SMITH AND SAYERS FAMILY **DIVISION SUBDIVISION**

APPLICATION NUMBER 20 DATE February 7, 2013
APPLICANT Smith and Sayers Family Division Subdivision
REQUEST Subdivision

DETAIL SITE PLAN

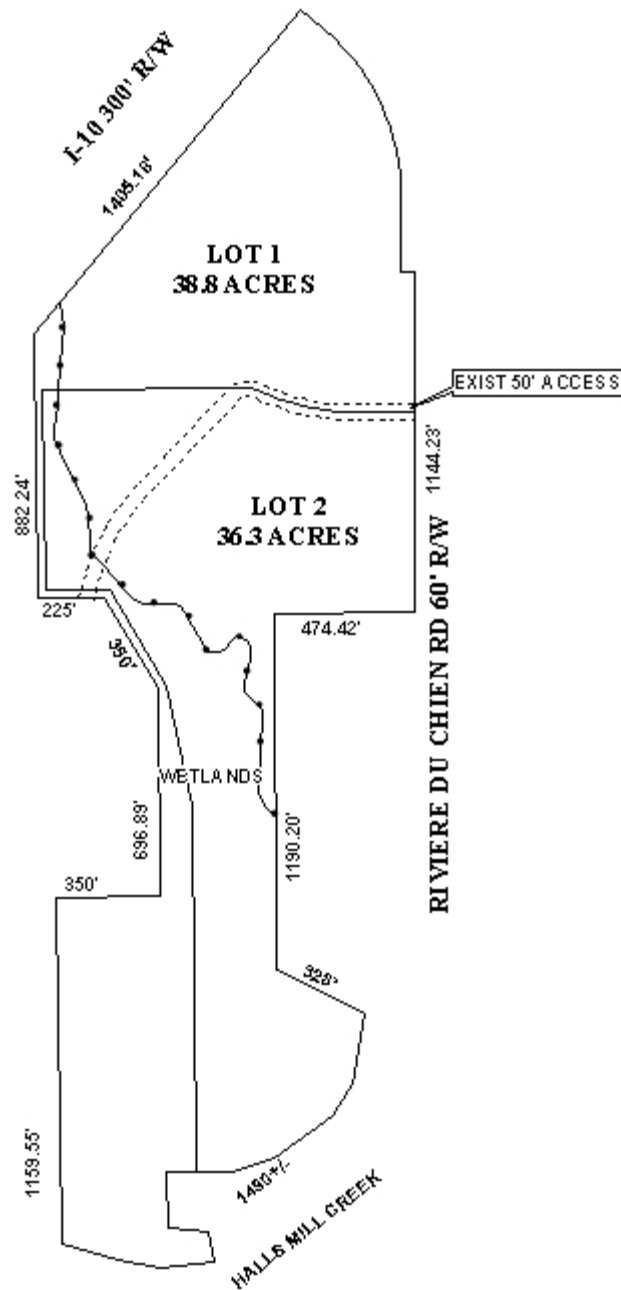
The purpose of this application is to create two legal lots of record from four legal lots of record and six metes and bounds parcels. The lot sizes are labeled, and the proposed lots would exceed the minimum size requirements of Section V.D.2. of the Subdivision Regulations. The lot size should be retained in square feet and acres on the Final Plat, as on the preliminary plat, if approved. The lots are unusually shaped in order to provide them both with access to the water as well as street frontage. Because unusual shaped lots are not uncommon in the area, but not as proposed. The preliminary plat should be revised to illustrate the wetland as common area, therefore creating more regularly shaped lots.

The site fronts onto Interstate 10, a major street, which is illustrated as having a 300' right-of-way. According to the Major Street Plan, Interstate 10 should have a right-of-way of 350'; therefore dedication to provide 175' from the centerline should be required. The site also fronts onto Riviere Du Chien Road, a minor road without curb and gutter, which is illustrated as having

a compliant 60' right-of-way; as such, no dedication is required. It should also be noted that the preliminary plat illustrates a 50' wide access road to an otherwise land-locked adjacent parcel.

The 25-foot minimum building setback line, required in Section V.D.9., is not illustrated on the preliminary plat. If approved, the 25-foot building setback line should be illustrated and labeled along all frontages on the Final Plat.

As a means of access management, a note should be placed on the Final Plat limiting each lot to one curb cut to Riviere Du Chien Road, with the size, design, and location of the curb cut to be approved by Traffic Engineering and conform to AASHTO standards.

The southern portion of the site contains a portion of Halls Mill Creek, and wetlands associated with the creek are illustrated on a portion of the site. The site, additionally, appears to be partially located in the "floodway" and "100-year" frequency flood zone as depicted on FEMA maps, and thus may be subject to flooding. The presence of wetlands and floodplains indicate that the area may be environmentally sensitive; therefore, the approval of all applicable Federal, state and local agencies would be required prior to the issuance of any permits or land disturbance activities.

- 1) revise the preliminary plat to illustrate the wetland as common area.
